**Response to**  
**Request for Additional Information No. 351, Supplement 2**

**U.S. EPR Standard Design Certification**  
**AREVA NP Inc.**  
**Docket No. 52-020**  
**SRP Section: 09.02.05 - Ultimate Heat Sink**  
**SRP Section: 09.05.01 - Fire Protection Program**

**QUESTIONS for Balance of Plant Branch 1 (AP1000/EPR Projects) (SBPA)**

Figure 2.7.11-1—Essential Service Water System Functional Arrangement  
Sheet 1 of 9

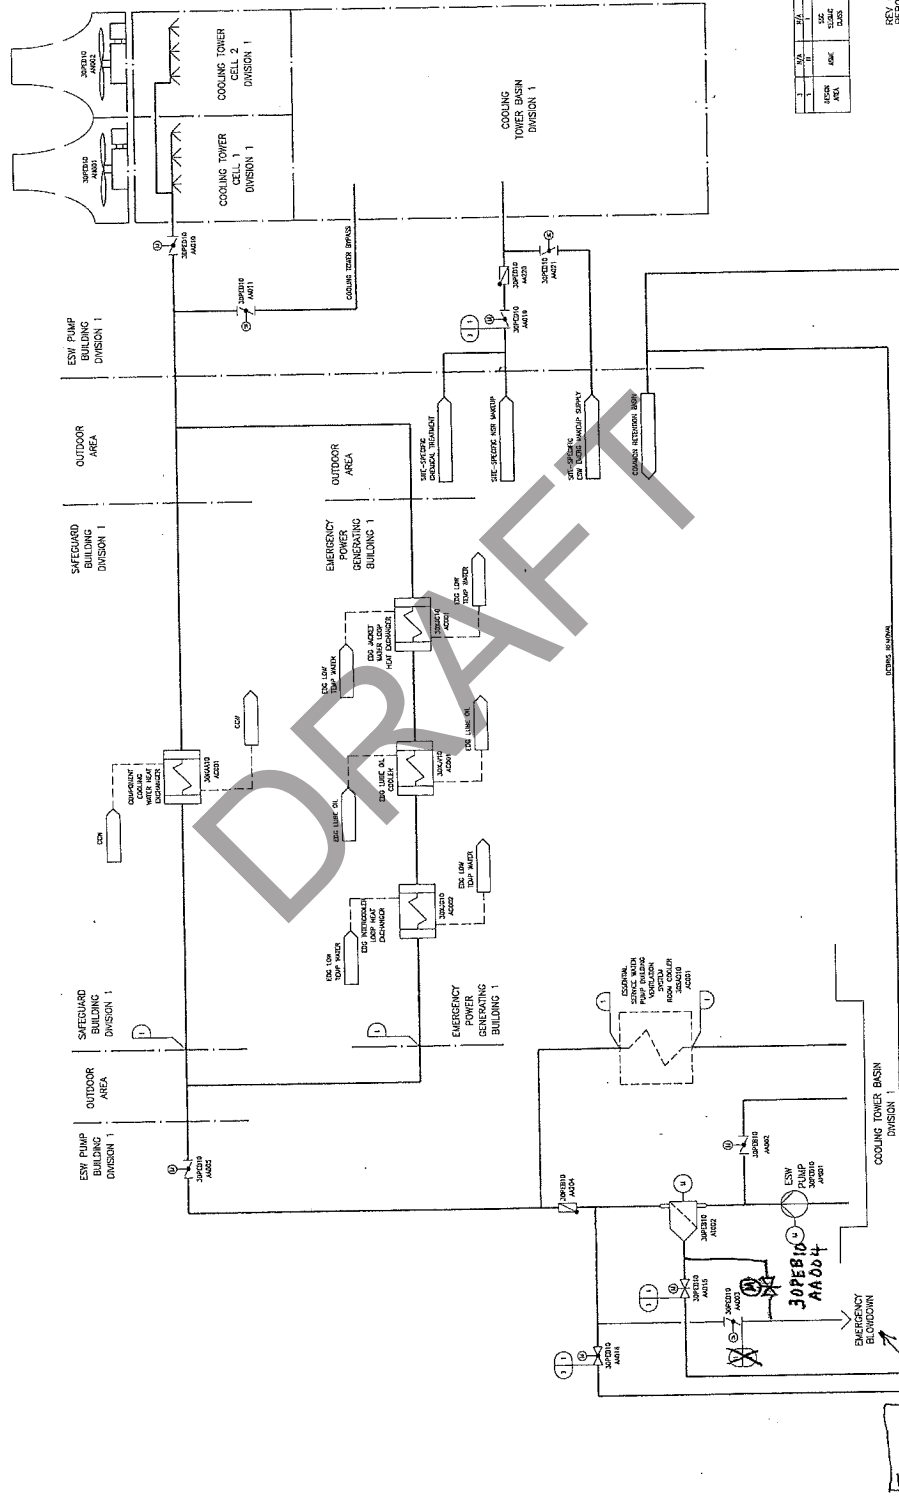
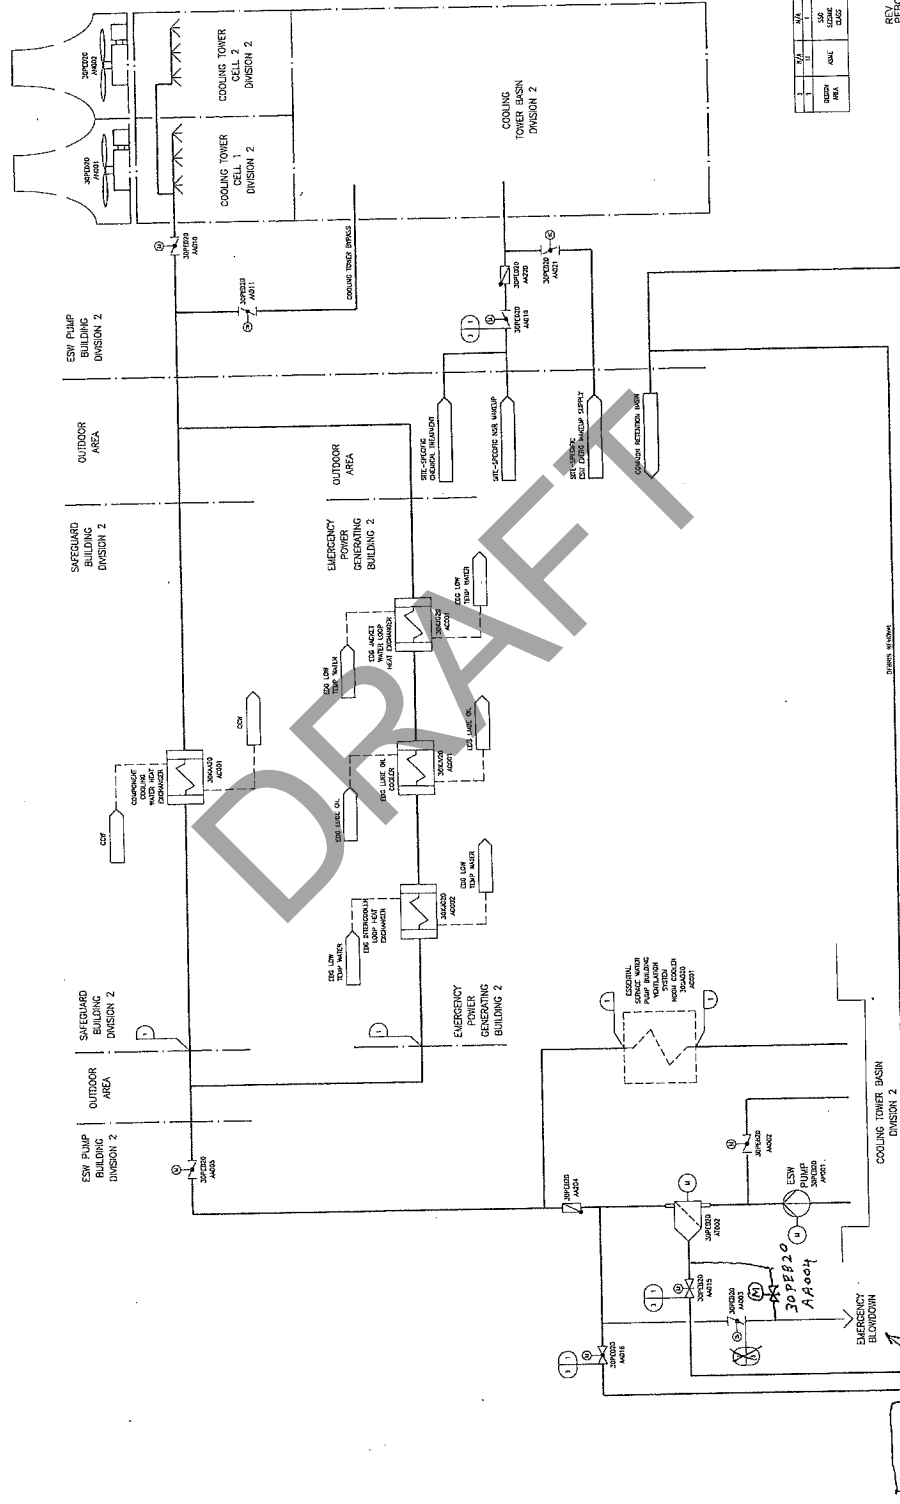
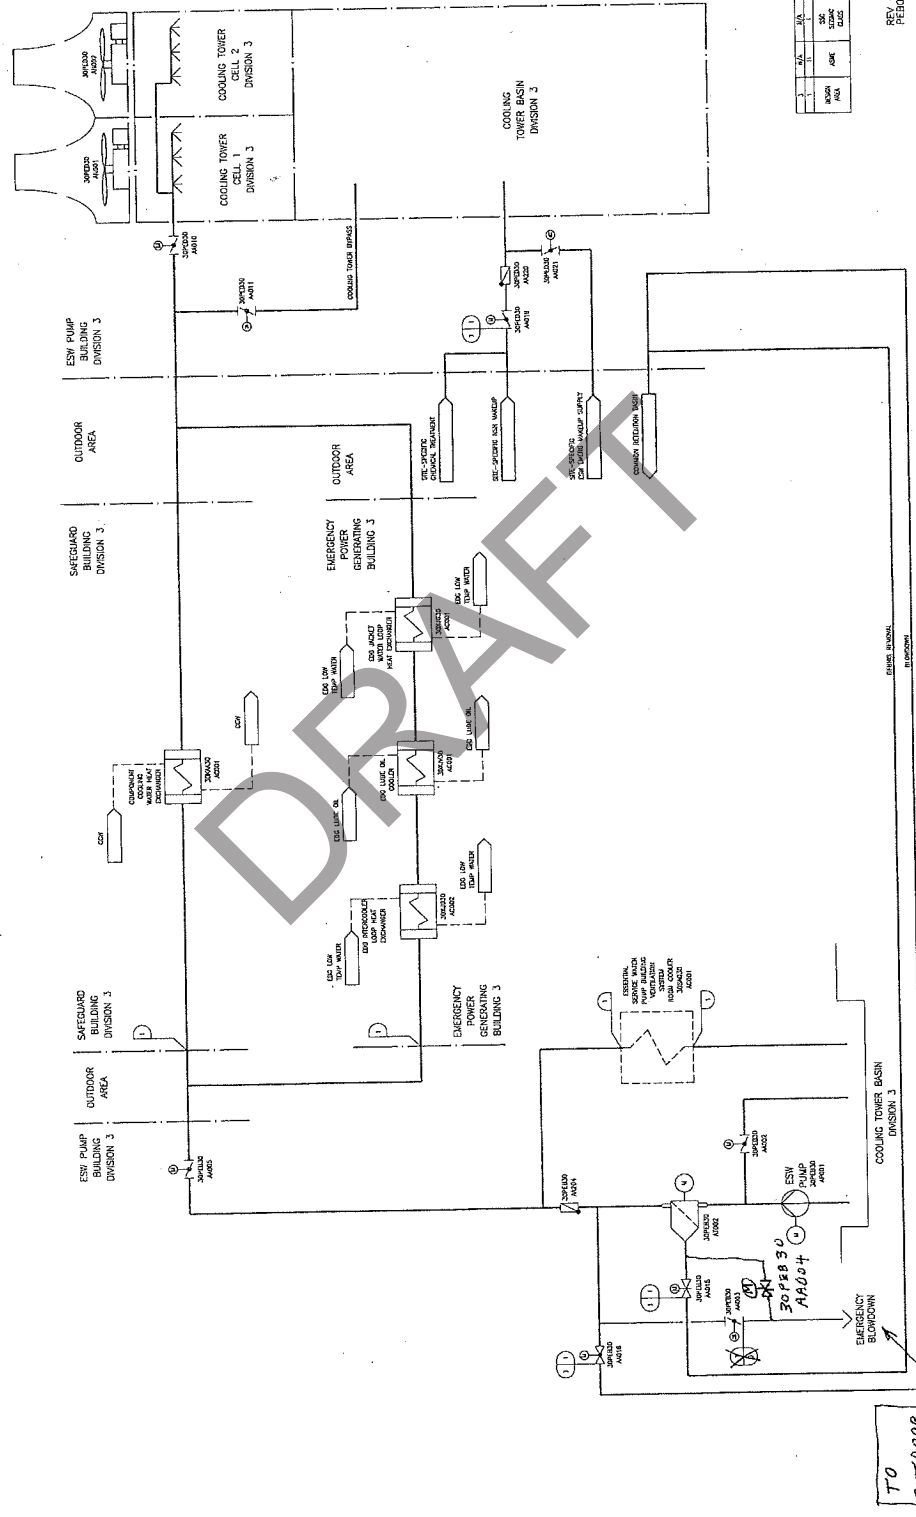
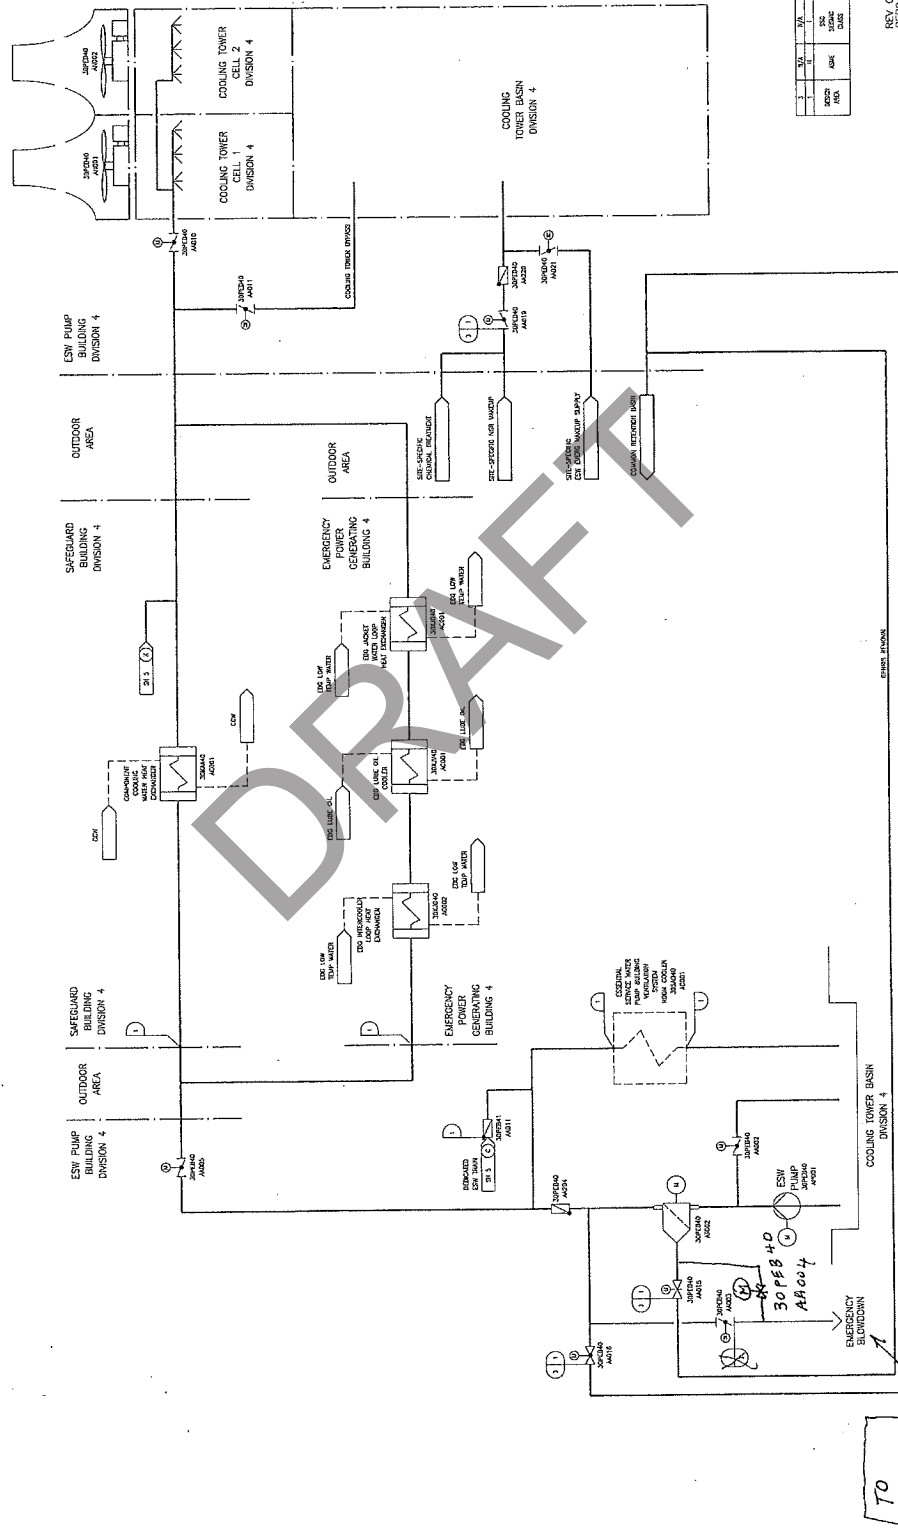
The applicant response indicates that non-safety-related system piping is seismically analyzed for adverse interaction with safety-related structures, systems, and components and refers to FSAR Tier 2, Section 3.7.3.8, for additional information. However, the response did not address the effects of flooding due to failure of non-safety-related piping associated with the essential service water system and the ultimate heat sink, and additional information is needed to assure that the consequences of flooding in this regard will not pose a threat to safety-related equipment. Additionally, since the blowdown piping for the cooling tower basins is non-safety-related, the effects of cooling tower basin overflow due to torrential rains and hurricanes need to be addressed. The FSAR should be revised to include this information as appropriate.

To ensure the function of the safety related filter, an alternate safety related filter blowdown path is provided as shown in the FSAR Figure 9.2.1-1 being revised. The new line includes valve 30PEB10/20/30/40AA004, Filter Emergency Blowdown Isolation Valve.

Revised IAW RA1351 Q 09.02.05-22

Figure 9.2.1-1—Essential Service Water System Piping & Instrumentation Diagram  
Sheet 3 of 4

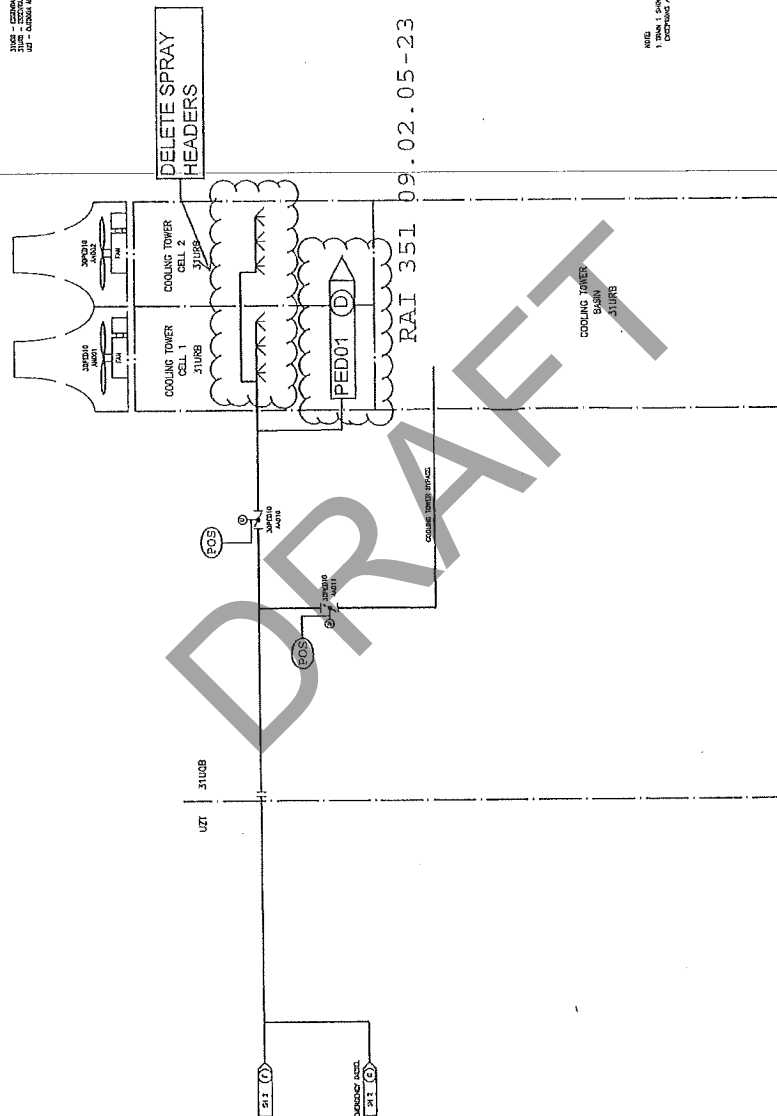
- c. FSAR Tier 2 Figure 9.2.1-1, Sheet 3, and Figure 9.2.5-1 both show that the chemical treatment system is only connected to the normal makeup system and not to the safety-related emergency makeup system. This appears to be in error and the applicant should correct or explain.

- c. This is not in error. The chemical treatment system is non-safety site specific system that provides water treatment chemicals to the normal make up water system. The chemical treatment system is not needed during emergency operation. Details related to chemical treatment for the safety-related emergency makeup system are the responsibility of the COL applicant as indicated in Tier 2 Figure 9.2.5-2.

RAI 351 09.02.05-23

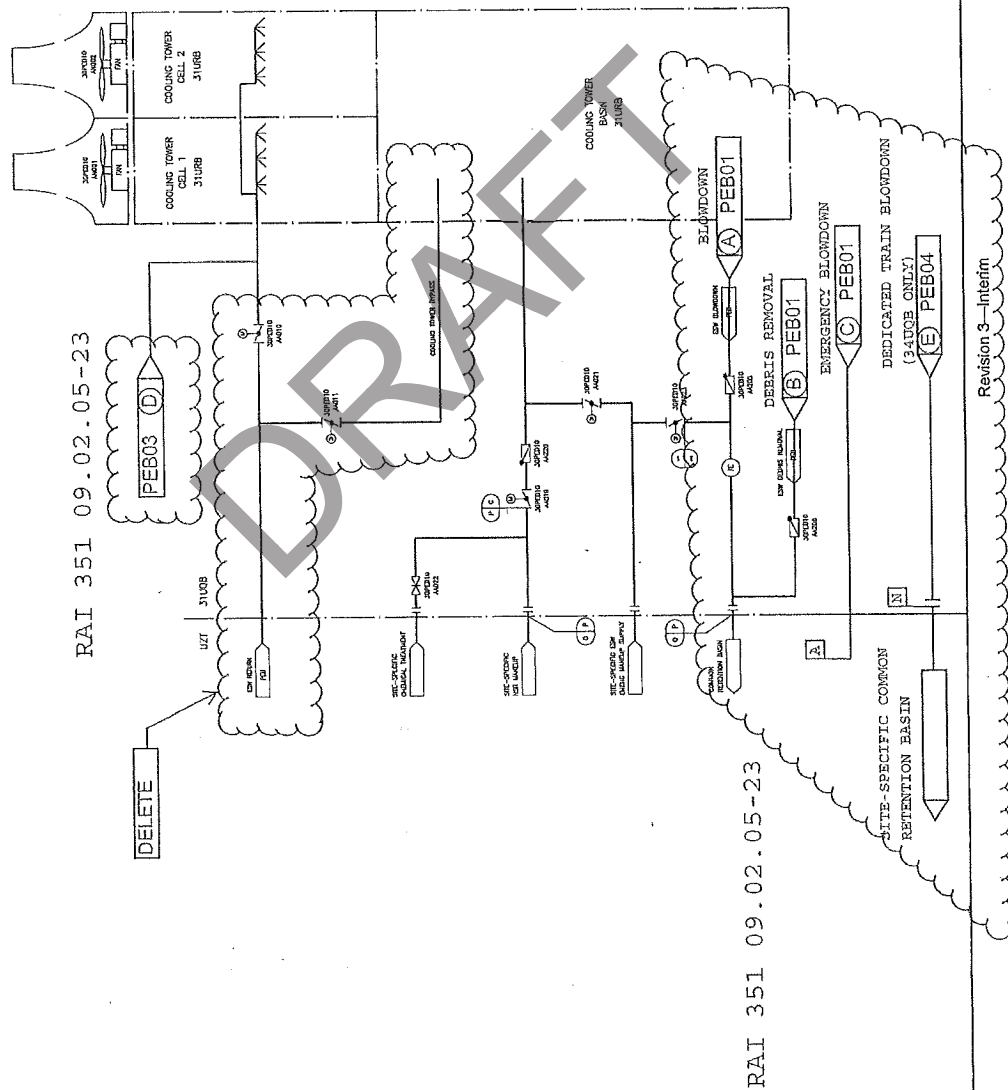
- f. The UHS fan alarms are not discussed in the FSAR.
- g. Figure 9.2.5-1 does not show the cooling tower basin instruments (level and temperature).

The applicant's response for Items (d) and (g) refer to Tier 2 FSAR Section 9.2.1 for information pertaining to certain UHS valves and instruments. The description and piping and instrumentation diagram for the UHS should show those items that are part of the UHS and Tier 2 FSAR Section 9.2.5 should address these items accordingly. Likewise, Tier 2 FSAR Section 9.2.1 should describe and address those items that are designated as part of the essential service water system. Consequently, Tier 2 FSAR Sections 9.2.1 and 9.2.5 and associated figures need to be revised to clearly indicate which items are included within their respective scopes and to describe those items accordingly. The following additional items are also related to this issue:

- a. Dedicated and emergency ESWS blowdown are not shown on FSAR Tier 2 Figure 9.2.5-1 as UHS support systems
- b. Interface flange connections are not shown on FSAR Tier 2 Figure 9.2.5-1 for the dedicated and emergency ESWS blowdown support system.

- a. See response above concerning the dedicated and emergency ESWS blowdown system. The emergency ESWS blowdown system is shown on U.S. EPR FSAR Tier 2, Figure 9.2.1-1, Sheet 1, Essential Service Water System Piping & Instrumentation Diagram. The dedicated ESWS blowdown system is shown on U.S. EPR FSAR Tier 2, Figure 9.2.1-1, Sheet 4. A conceptual design for the emergency ESWS blowdown system is indicated in the response to RAI 175 Supplement 2, Question 09.02.05-20, Figure 9.2.5-2 [[ Conceptual Site-Specific UHS Systems]]. Figure 9.2.5-2 will be revised to show the dedicated blowdown system and the change in classification of emergency ESWS blowdown piping indicated in the response to RAI 351 Question 09.02.05-22.

- b. Refer to response to RAI 351, Question 09.02.05-22, markup of U.S. EPR FSAR, Figure 9.2.1-1, Sheet 1 for additional information concerning the emergency ESWS blowdown system. U.S. EPR FSAR Tier 2, Figure 9.2.1-1 Sheet 4 will be revised to show the off-page connection for the ESWS dedicated blowdown system to Tier 2 Figure 9.2.5-1 and the site-specific interface.

**Figure 9.2.5-1—Ultimate Heat Sink Piping and Instrumentation Diagram**

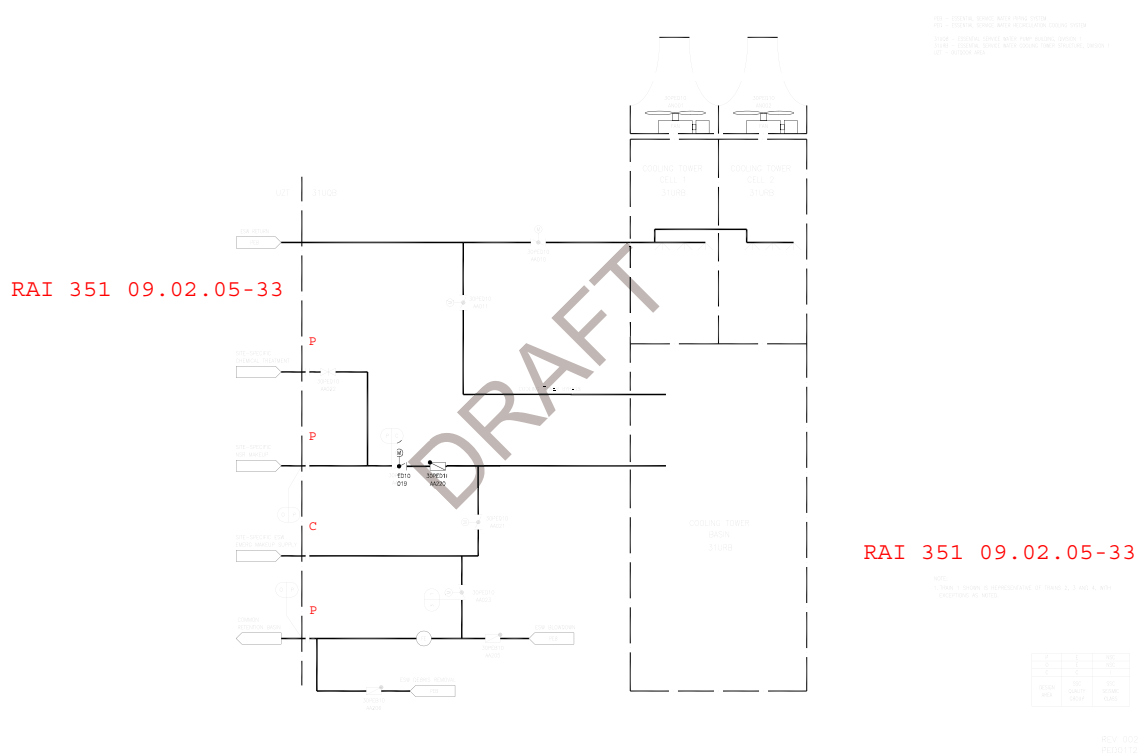
- a. Pipe sizes are not shown on the P&ID (Figure 9.2.5-1, "Ultimate Heat Sink Piping and Instrumentation Diagram"), and the system description in Section 9.2.5 does not explain the criteria that were used in establishing the appropriate pipe sizes (such as limiting flow velocities).

- c. Figure 9.2.5-1 does not show the location of indications (e.g., local, remote panel, control room), and identify the instruments that provide input to a process computer and/or have alarm and automatic actuation functions.

- d. Figure 9.2.5-1 does not show identify the normal valve positions are, identify the valves that are locked in position, and identify the valves with automatic functions; and these design features are not described in Section 9.2.5.

Figures 9.2.5-1 and 9.2.5-2 will be revised to clarify the scope of the certified design for the UHS support systems.
